MEMO

To: Greg Seidel, Balmoral
From: Jessica Fish, SEARCH
CC: Central Florida Expressway
Date: 9/6/2022
Re: SR 429 and Binion Road Interchange Study Area (CFX Project #429-309)

Figure 1. Previously recorded cultural resources in the SR 429 and Binion Road Interchange Study Area.

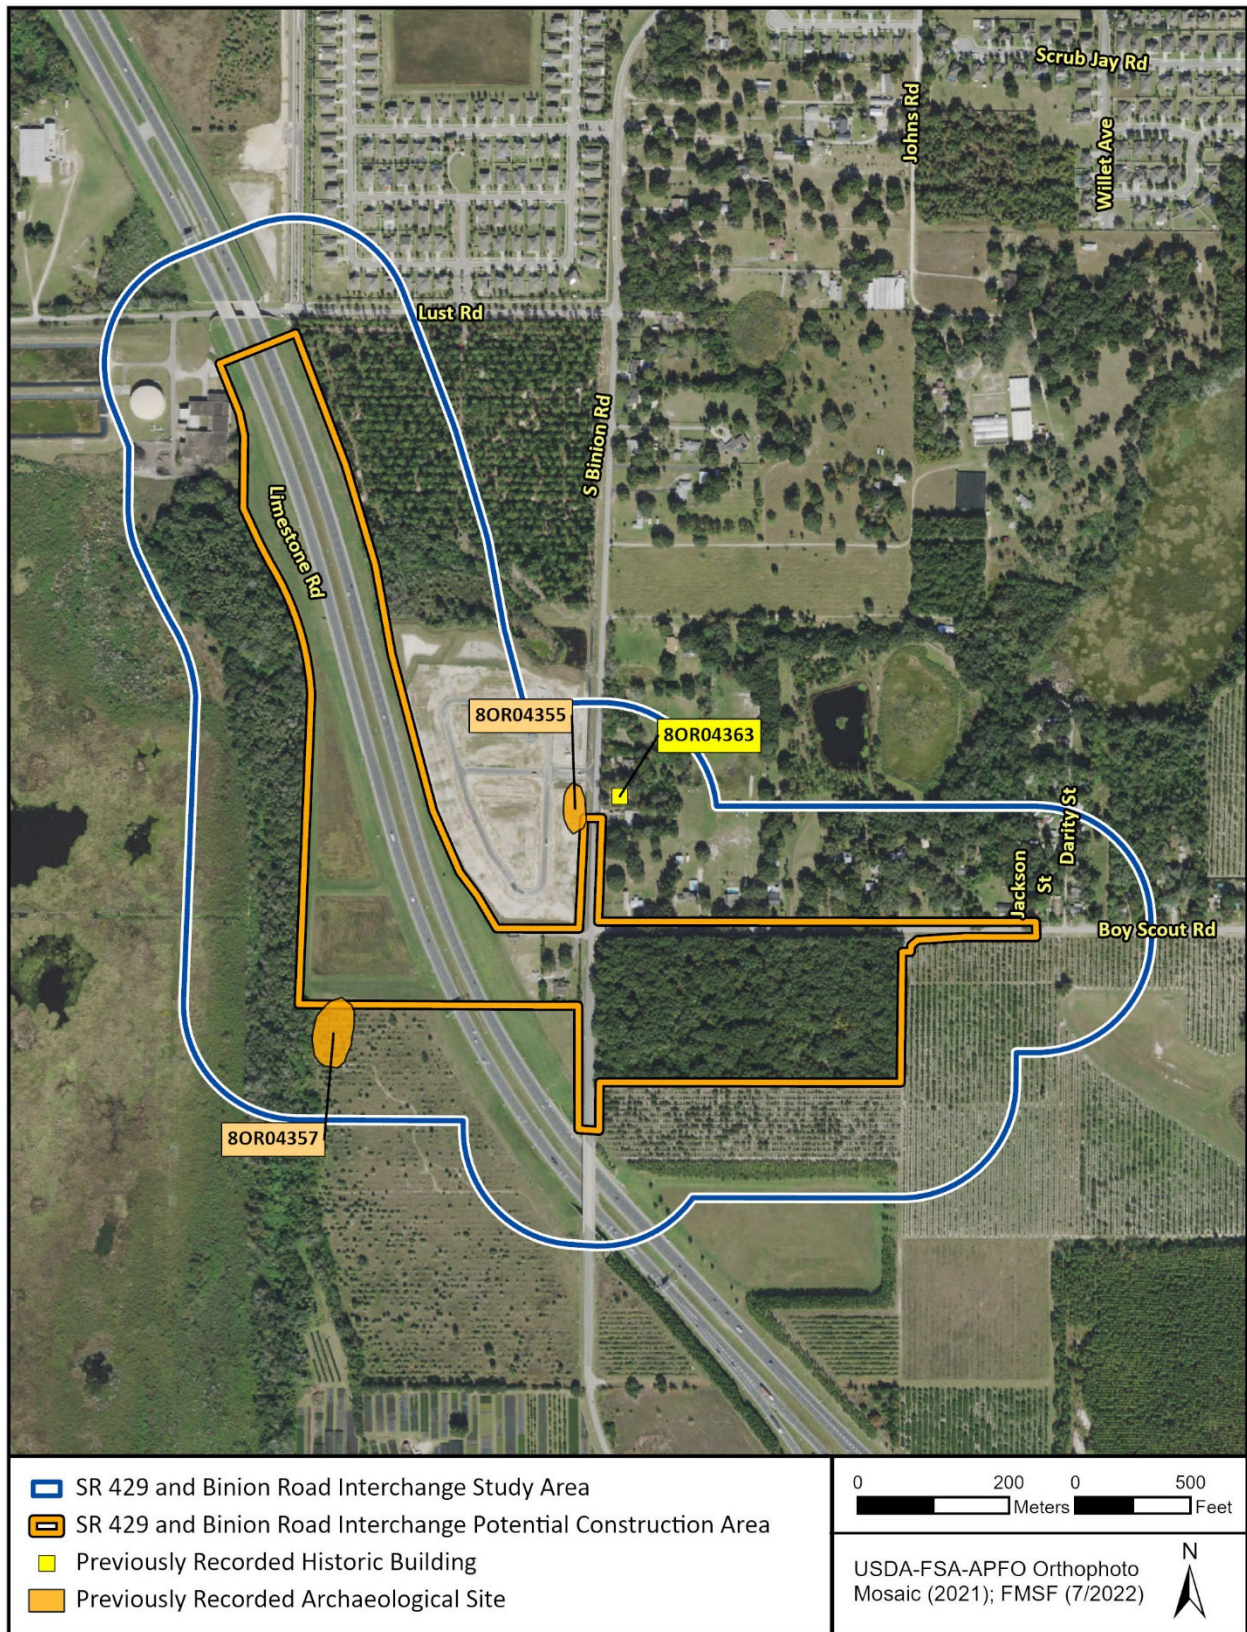
On September 6, 2022, SEARCH reviewed concept plans for the construction of the Binion Road and State Road (SR) 429 interchange, which will include the realignment of Boy Scout Road (**Figure 1**). The purpose of this review was to identify any previously recorded cultural resources within the project area. The Study Area was defined as the parcels where the proposed interchange will be built (the potential construction area) in addition to a 152-meter (500-foot) buffer to address any potential viewshed effects to historic resources (see **Figure 1**). The entire parcels were included in the construction area to accommodate potential lay down or storage areas which have the potential to disturb subsurface deposits. The present document is for information purposes only and does not satisfy any requirements under the National Environmental Policy Act or Section 106 of the National Historic Preservation Act.

Two previously recorded archaeological sites (8OR04357 and 8OR04355) and one building (8OR04363) have been recorded within the SR 429 and Binion Roach Interchange Study Area (**Table 1**; see **Figure 1**). All three resources have been previously recommended ineligible for the National Register of Historic Places (NRHP) by the State Historic Preservation Officer (SHPO).

Review of the FMSF database indicates that the current Study Area has only been partially surveyed by prior studies that meet the current Module Three standards for cultural resource surveys. Given the proximity of the Study Area to the Lake Apopka shoreline (indicating a high potential for precontact archaeological sites), the presence of nearby cultural resources (which could indicate additional resources may be present), and the lack of sufficient cultural resource survey throughout the Study Area, a Phase I Cultural Resource Assessment Survey (CRAS) is recommended for this project.
